**MODIFICATION REQUEST:
(MP 09_0184 Mod 5)**

***Modification Request for Installation of
Ventilation Ducts along the Western Elevation
of the Costco Development at 17-21 Parramatta
Road, Auburn***

Director-General's
Environmental Assessment Report
Section 75W of the
Environmental Planning and Assessment Act 1979

September 2012

Figure 2: Location of Proposed Ventilation Ducts on Western Elevation

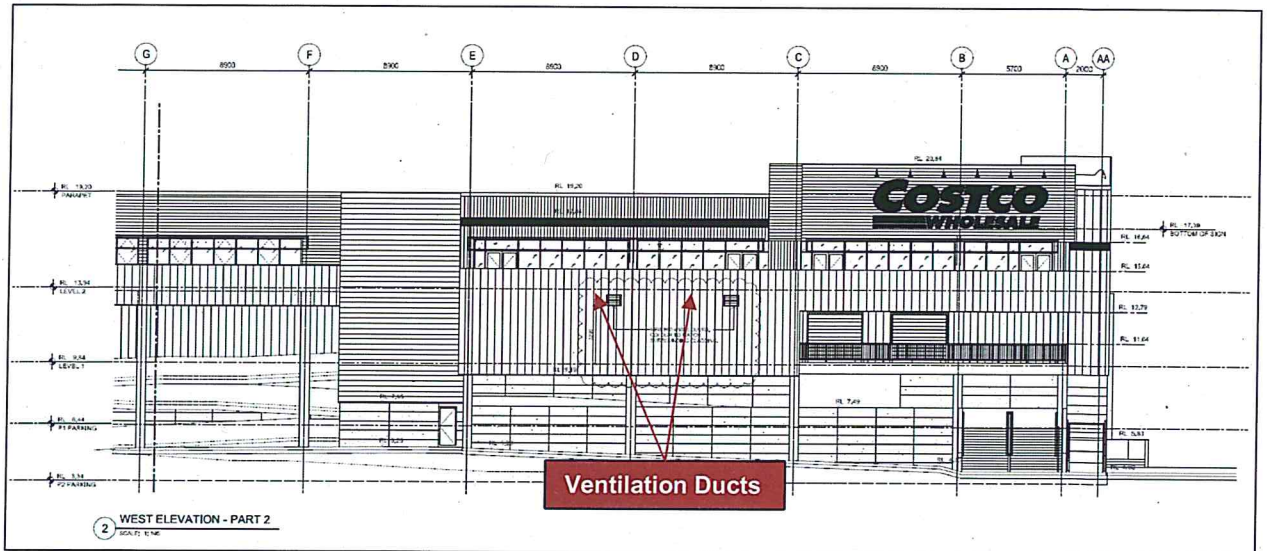
The proposed modification comprises the installation of two 800mm x 600mm louvred ventilation ducts on Level 1 of the western elevation of the Costco Wholesale Retail Warehouse building (**Figure 2**). The modification also seeks to replace approved plan no. A3-300-01 with revised plan no. SK 300-01 which shows the ventilation ducts on the western elevation.

The proposed modification is part of an upgrade to the ventilation system within the food court preparation area. The proponent has stated that the upgraded ventilation system is not dissimilar to the system approved in the construction certification documentation for the original development.

The louvred ventilation ducts are located a minimum of 7.2m above ground level along the western elevation of the existing building. The western elevation presents to Haslems Creek and is only visible to the public when travelling east along Parramatta Road.

The western elevation is articulated and contains a corner element where "Costco" signage is located. The proposed ventilation ducts would be integrated into the western elevation and will not be a discernible feature along the elevation.

To install two louvred ventilation ducts along the western elevation.
